PUBLIC INTEREST REVIEW FOR GROUNDWATER APPLICATIONS

SUBJECT: Application G- 17879 Supersedes review of N.A.
Date of Review(s)

A. GENERAL INFORMATION: Applicant's Name: Silvies Valley Ranch Water Co. LLC County: Grant

A1. Applicant(s) seek(s) 3.899 (1750 gpm) cfs from 3 well(s) in the Malheur Lake Basin,
Silvies River subbasin Quad Map: Silvies

EXEMPT USE WELL LOCATION MAP

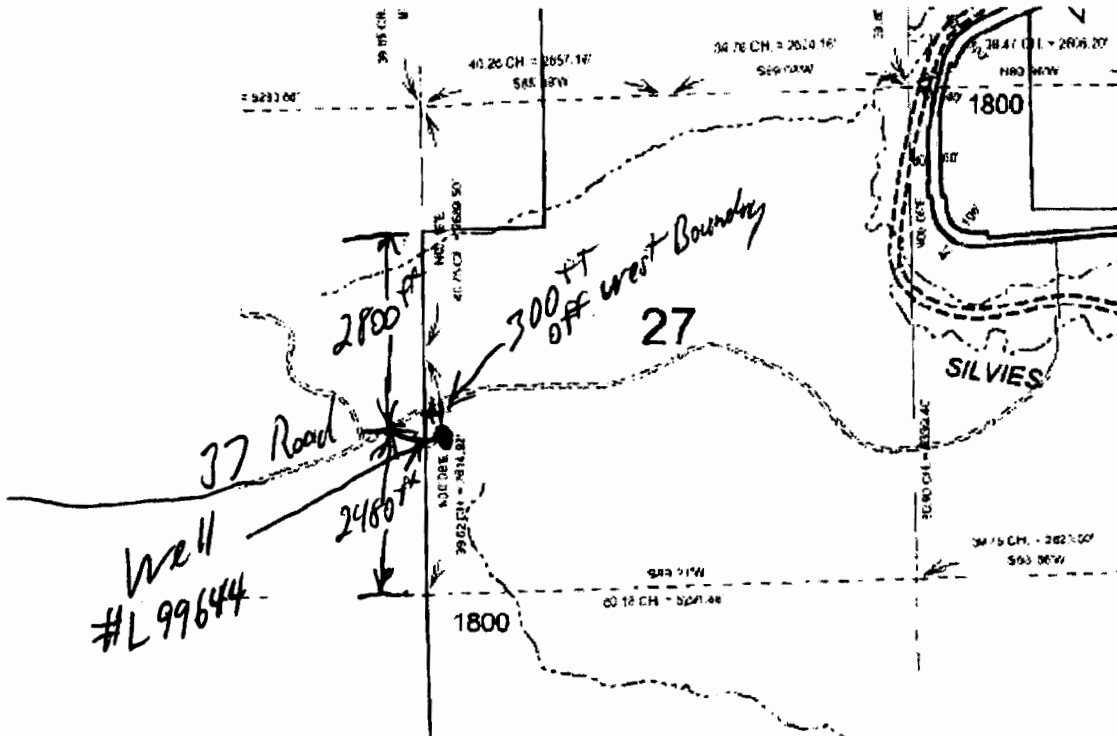
One of the three POA wells exist (GRAN 51009). The water well report (well log) indicates the 346 feet deep well penetrated one-foot of soil, 19 feet of conglomerate, 25 feet of hard claystone, 15 feet of casing broken rock, and lastly, 286 feet of broken black basalt. Water was reportedly encountered from 23 to 346 feet depth and the static water level reportedly remained constant at 23 feet below land surface (4857 ft. elevation). Near the proposed POA wells, Camp Creek is about 4640 feet elevation and Silvies River is about 4600 feet elevation, which is more than 200 feet below the reported static water level at GRAN 51009.

Available data related to well 1 (GRAN 51009) indicates groundwater in the uplands composed of marine sedimentary and volcanic rocks (Jtl) is generally unconfined given the static water level was reportedly the same as where first water was encountered at the well and no change in static water level was reported with increasing well depth. If the water well report for GRAN 51009 is correct, the static groundwater level appears to be more than 200 feet above the nearby Silvies Valley and the groundwater within the Silvies Valley alluvium.

Condition for re-construction of existing POA well GRAN 51009: "Existing POA well GRAN 51009 (well tag L-99644) shall be reconstructed to have continuous casing and continuous seal from land surface or above to a depth of 65 feet or more below land surface."

Groundwater Permit Application G-17879 Silvies Valley Ranch Water Co. LLC

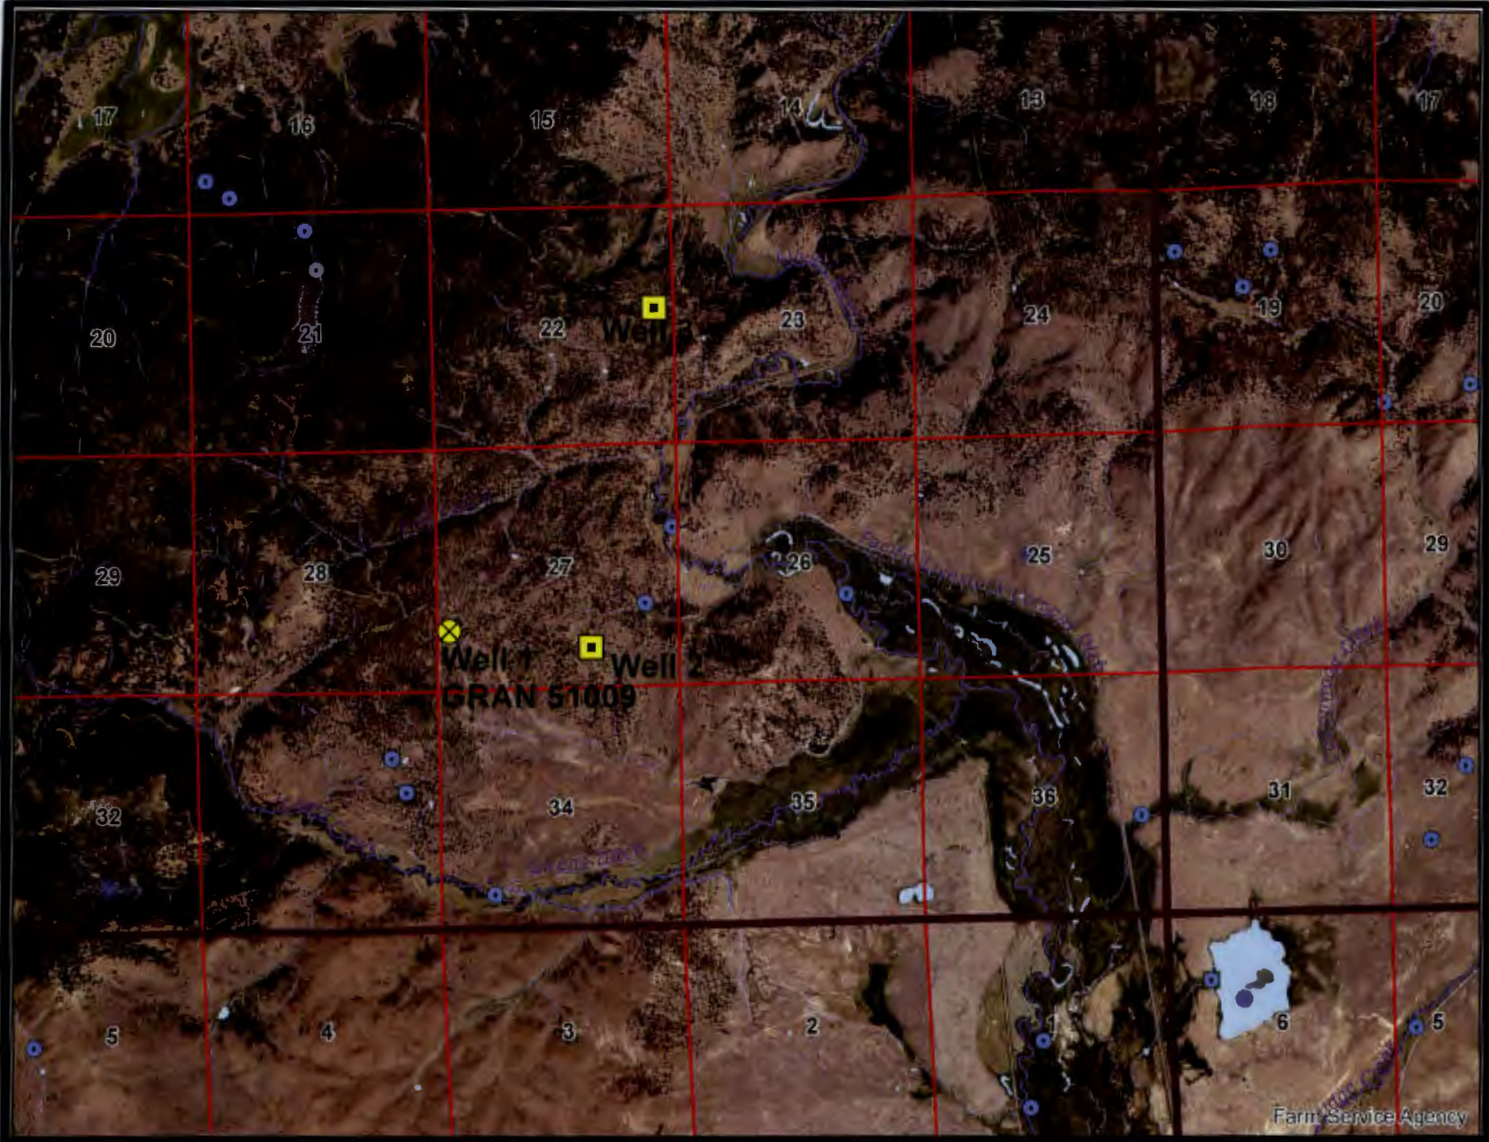
The proposed aquifer is inferred from the mapped geology at the well locations. All three proposed POA wells are located in Grant County south of Seneca in uplands that are northwest and immediately adjacent to Silvies Valley. Camp Creek is to the south of the wells, and the upper portion of the Silvies River is east of the wells. Brown and Thayer (1966) mapped the well locations as Jurassic Age sedimentary and volcanic rocks that correspond to the Trowbridge and Lonesome Formations described by Luper (1941) and mapped by Dickinson and Vigrass (1965). The area's geology is discussed in more detail in section B3 (water availability).

The "closest spring (un-named)" for each proposed POA well is different. All of the "closest springs" identified in the table are in the same geologic unit as the proposed POA wells. Therefore, the springs are identified as hydraulically connected to the wells. Each spring identified discharges to an intermittent creek. Consequently, each spring identified is considered intermittent also, and consequently, a potential for substantial interference cannot be assumed even though the well to spring distance is less than ¼ mile for two proposed POA wells. No water rights were found associated with the springs or their adjoining creek.

Camp Creek is located south of the POA wells. The creek is identified as perennial, and it is tributary to the Silvies River. It drains a relatively narrow valley whose lower reach is bounded by uplands composed of marine sedimentary and volcanic rocks (Jtl). Geologic mapping indicates the lowest creek reach flows on alluvium (Oa) and the reaches above flow on rock exposed in the adjoining upland. Groundwater at the proposed POA wells appears to be inefficiently connected to Camp Creek given the apparently large water elevation difference. However, the creek likely receives groundwater discharge from the uplands bounding the creek valley. No potential for substantial interference was assumed given the POAs are more than 0.25 mile from the creek as well as the apparently large water elevation difference.

Silvies River is located east of the POA wells. The river is identified as perennial. Locally, it drains a valley bounded by uplands composed of marine sedimentary and volcanic rocks (Jtl). Geologic mapping indicates the river flows on alluvium (Oa). Groundwater at the proposed POA wells appears to be inefficiently connected to river given the apparently large water elevation difference. However, the river likely receives groundwater discharge from the uplands bounding the river valley. No potential for substantial interference was assumed given the POAs are more than 0.25 mile from the river as well as the apparently large water elevation difference.
